12.1 DEVELOPMENT APPLICATIONS

12.1.1 Development Application for the 'Midlands Community Recreation and Aquatic Centre' at the 'Council Depot Site', 18 Church St Oatlands, defined as an Indoor Recreation Complex in the Commercial and Residential Zones within the Historic Precinct Special Area. Development requires the demolition of existing buildings and seeks a variation to the development standards for height and side boundary setback

REPORT AUTHOR: PLANNING OFFICER (D CUNDALL)
DATE: 16TH SEPTEMBER 2013

Image 3_ Demonstrates the different scale of buildings in the vicinity of the proposal.

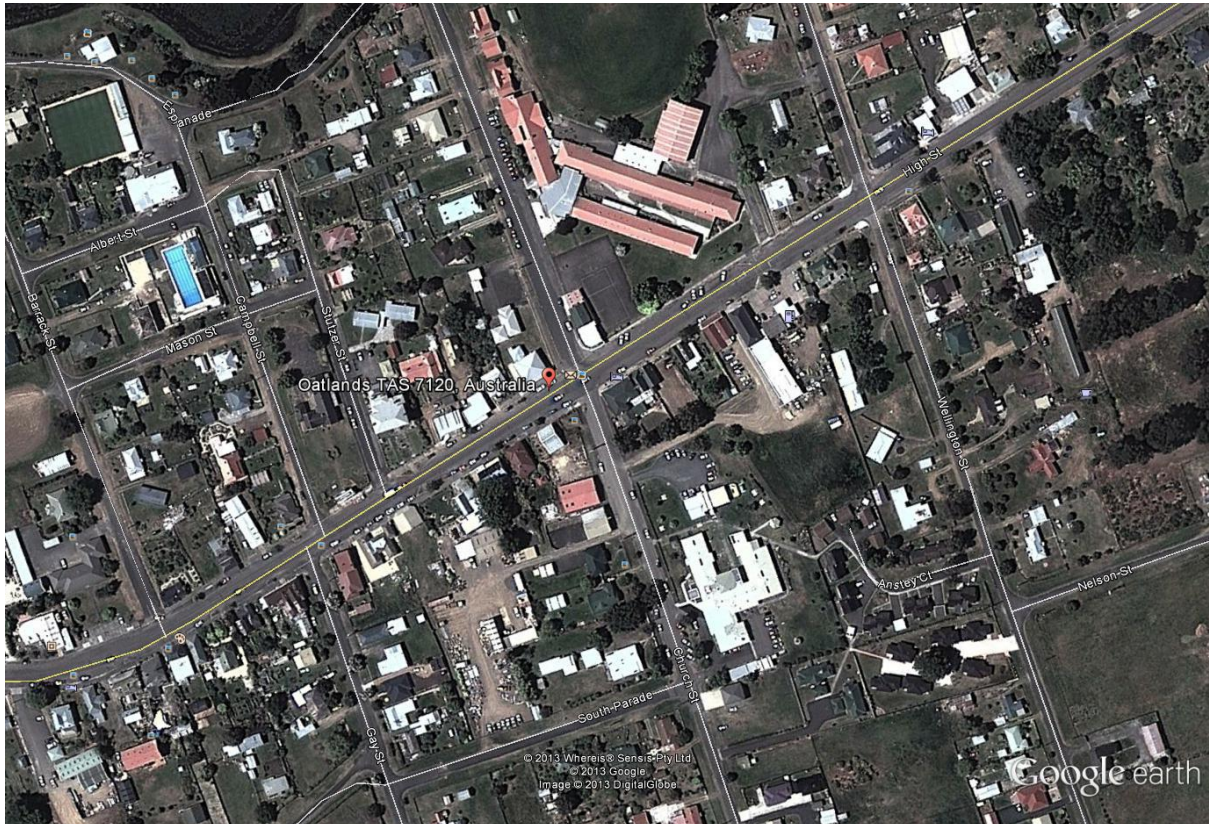
However looking at an aerial photograph of the town (see *Image 3* below) there is already two of the largest building in the town on the adjoining blocks. These buildings are the Midlands Multi-purpose Health Centre and the Oatlands District School.

This is not a reason in itself to allow for another large building. The Council must ensure that, even though this is a large building, every effort has been made to reduce the sense of scale and bulk and that the scale is not going to conflict with the immediate surroundings or set a precedent for large bulky buildings that may not be as conscientious to the scheme standards and surrounding amenity.

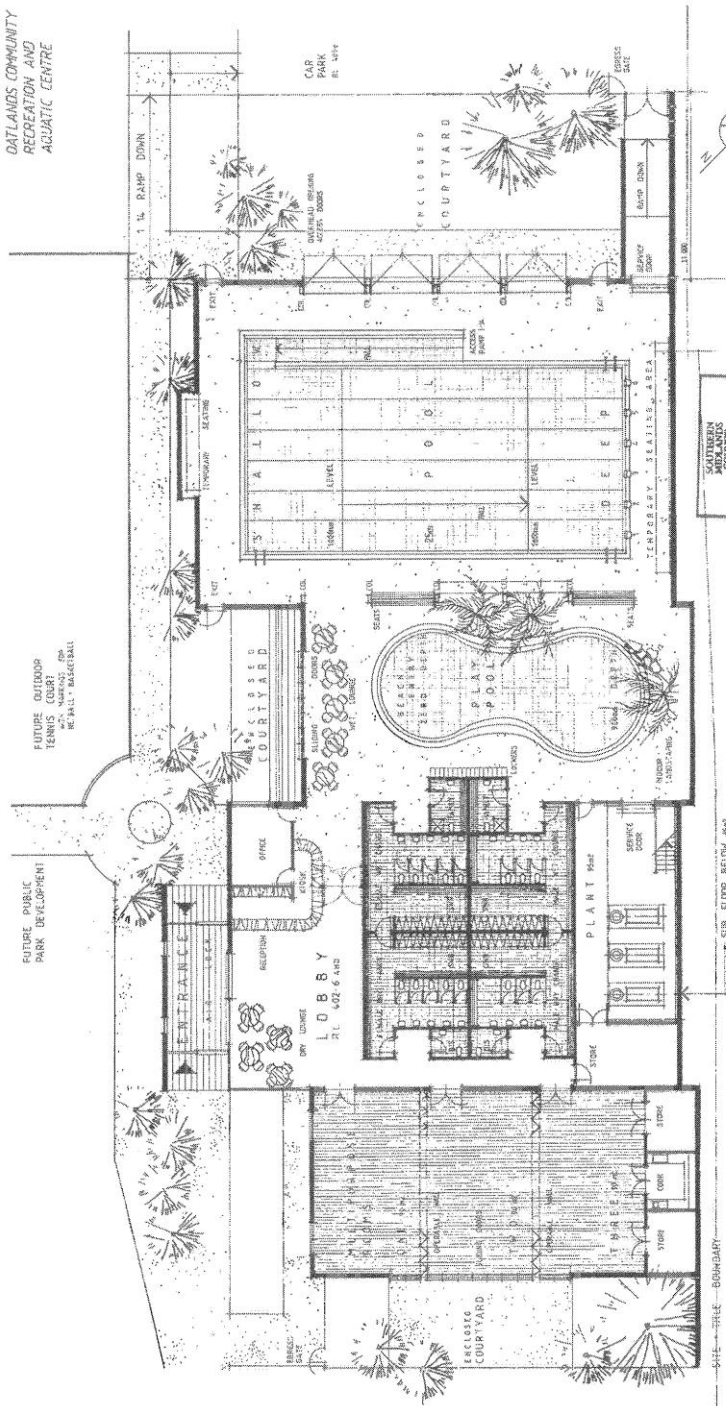
On site plan civil works drawing DA 003 Shows outdoor courtyard and on floor plan DA 004 shows enclosed courtyard. Which is correct as noise would be a problem when doors are open. If enclosed is there going to be a pitch roof or flat roof?

On drawing DA 004 if open how high would the proposed trees grow as maybe overshadowing would be a problem.

This is not a 'roofed courtyard'. The plan shows a courtyard enclosed by walls and trees. The idea is to create an open space for pool users on warmer days. The walls and trees are intended to mitigate noise.

The proposed species shown on the plan (adjoining the Gay St properties) are a mixture of small trees (upto 6m) and larger trees upto 15m (in the carpark area). Given the deliberate siting of these trees there is minimal overshadowing or nuisance to adjoining landowners. Quite possibly some minor shadowing very late in the day.
